Refrigerator not wired for 12Volt (DC)

Bulletin Type:	Technical Service Bulletin TSB	Publication Date:	March 9, 2021
Bulletin #:	21-002	Make(s):	Entegra Class B
Job Code(s):	9803565	Model(s):	Ethos
Flat Rate(s):	.50 Hour	Model Year(s):	2021

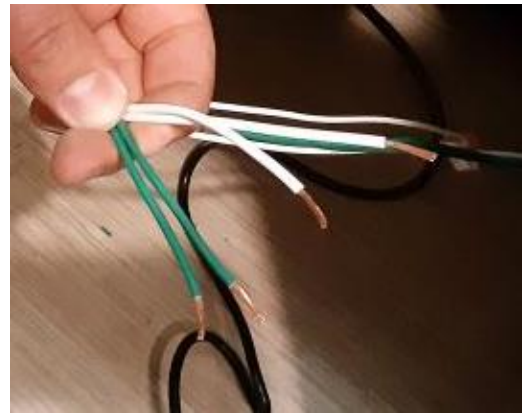
1. Remove the (2) screws from the bracket(s) that secure the refrigerator to the floor. Set the screws aside for re-use.

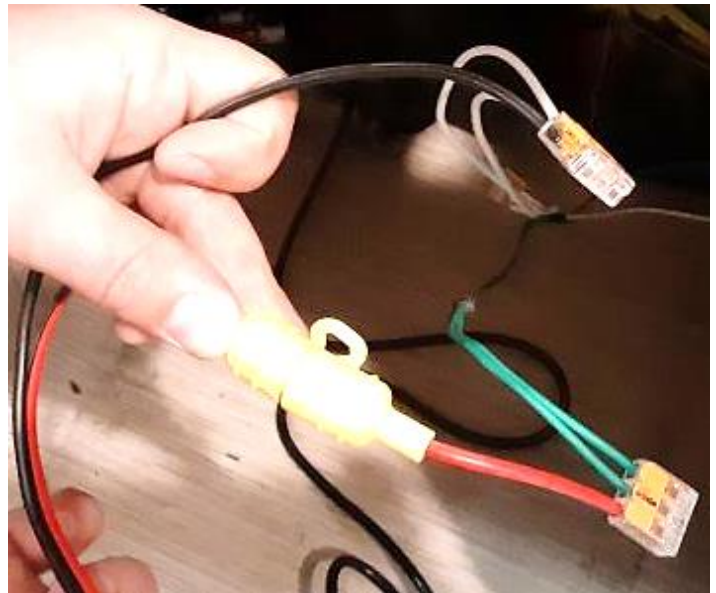
3. Unplug the refrigerator.
4. Locate the green and white wires. Cut both wires. Strip back the wires approximately 3/8".

5. Using the 12v refrigerator connector and a wago connector, connect the (2) green wires to the red wire (2) white wires with the black.
